Planning & Environment

MODIFICATION REQUEST:

***Concept Approval and Stage 1 Project
Approval at 110 – 114 Herring Road,
Macquarie Park***

MP10_0112 MOD 5 and MP 10_0113 MOD 5

Figure 6: Extract from plans, which shows that the storage areas, in conjunction with adjoining aisle area, have the same dimensions as adjoining parking spaces, and are therefore capable of conversion.

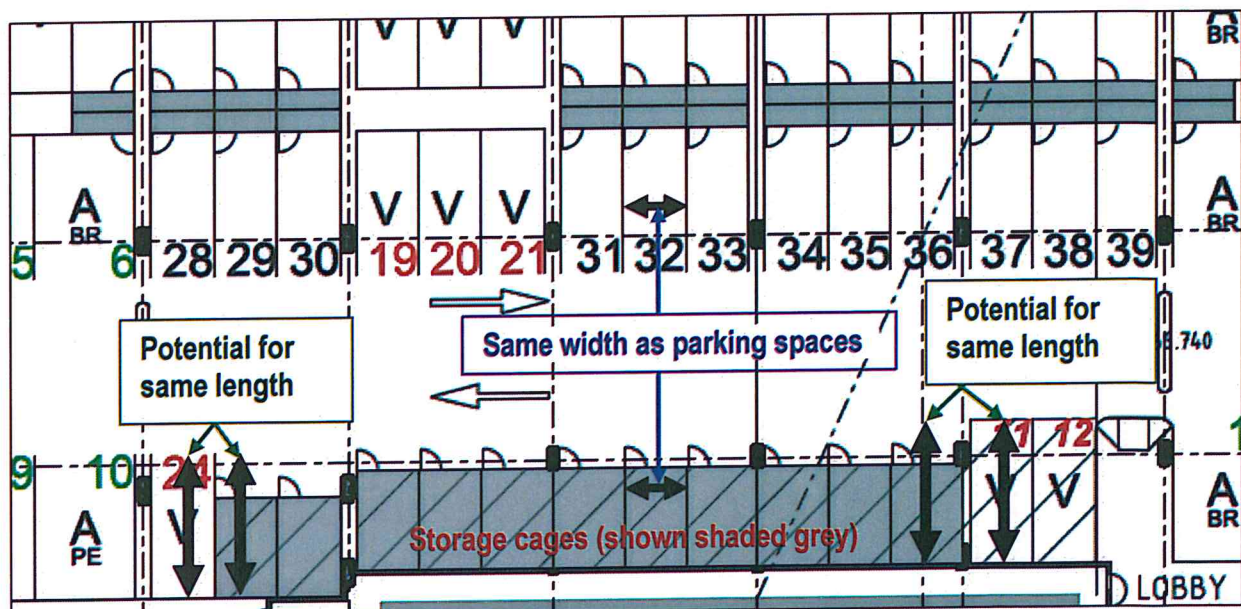
Council raised a concern regarding the possibility of the cages being capable of conversion to car parking spaces in the future.

The Department supports the provision of additional storage on the site in the form of the larger cages, and the proposal is consistent with the guidelines of the Residential Flat Design Code which encourages the provision of basement storage for large items such as sporting equipment. However, given the size and configuration of the storage cages and associated aisle widths, the Department also acknowledges there is an issue with possible informal conversion to car parking spaces in the future.

As can be seen in **Figure 6**, by comparing the width and length of surrounding parking spaces with the cages, there would be sufficient space (in conjunction with use of part of the adjacent aisle) to enable the conversion of these areas into parking spaces by removal of the cage.

To ensure that this storage space is not informally converted to car parking in the future, the Department recommends a condition requiring the retention of the storage cages and prohibition

on their use for parking, in conjunction with a section 88E restriction as to user to be registered on the title of the storage cages. This will ensure any future purchaser will be made aware of the prohibition of converting the storage cages into a parking space and will further aid in enforceability.
